| Title - Sujet Second Floor Fit-up - GOCB | |
| Solicitation No. - N° de l'invitation EV385-183075/A | Amendment No. - N° modif. 001 |

ADDENDUM #001:

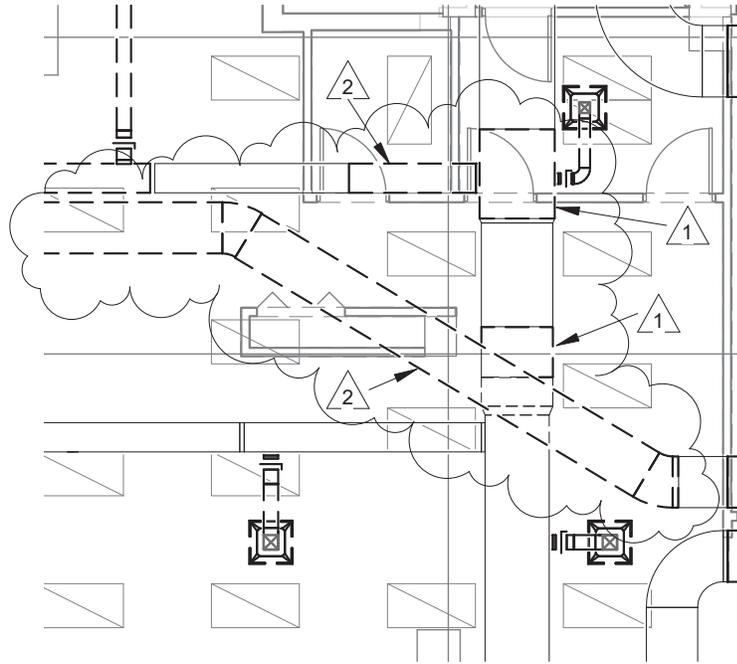
Refer to attached Mechanical RDM-01 and RDM-02. Revision cloud indicates area of changes to the original drawing set. All other items not tagged are to remain as per construction documents.

KEY NOTES

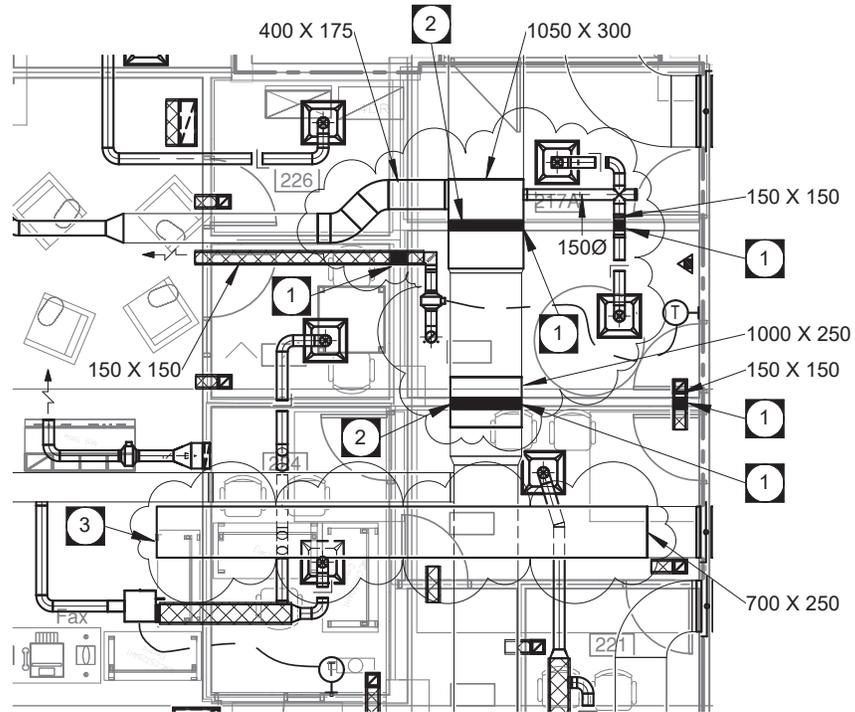
- 1 DEMOLISH EXISTING PORTION OF DUCTWORK AS REQUIRED TO ACCOMMODATE NEW SECURITY BARS DURING RENOVATION.
- 2 DEMOLISH DUCTWORK AS SHOWN TO ACCOMMODATE NEW WALL CONSTRUCTION DURING RENOVATION.

- 1 PROVIDE PRE-MANUFACTURED DUCT SECURITY BAR SYSTEM COMPLETE WITH DUCT SLEEVE. BARRIER BARS SHALL BE 13MM STEEL RODS, PLACED NO MORE THAN 150MM VERTICALLY AND 600MM HORIZONTALLY APART. SYSTEM SHALL BE FULLY WELDED. CONTRACTOR TO CONFIRM SLEEVE LENGTH ON SITE PRIOR TO ORDERING. INSTALL AS PER MANUFACTURER INSTALLATION GUIDELINES.
- 2 WHERE SECURITY BAR SYSTEM EXCEEDS MAXIMUM ALLOWABLE DIMENSIONS AS SET BY THE MANUFACTURER, CONTRACTOR SHALL FIELD WELD SECTIONS OF SECURITY BAR SYSTEMS TOGETHER TO FULLY COVER DUCT OPENING. REFER TO MANUFACTURER GUIDELINES FOR REQUIREMENTS.
- 3 OPEN ENDED DUCT WITHIN DROPPED CEILING.
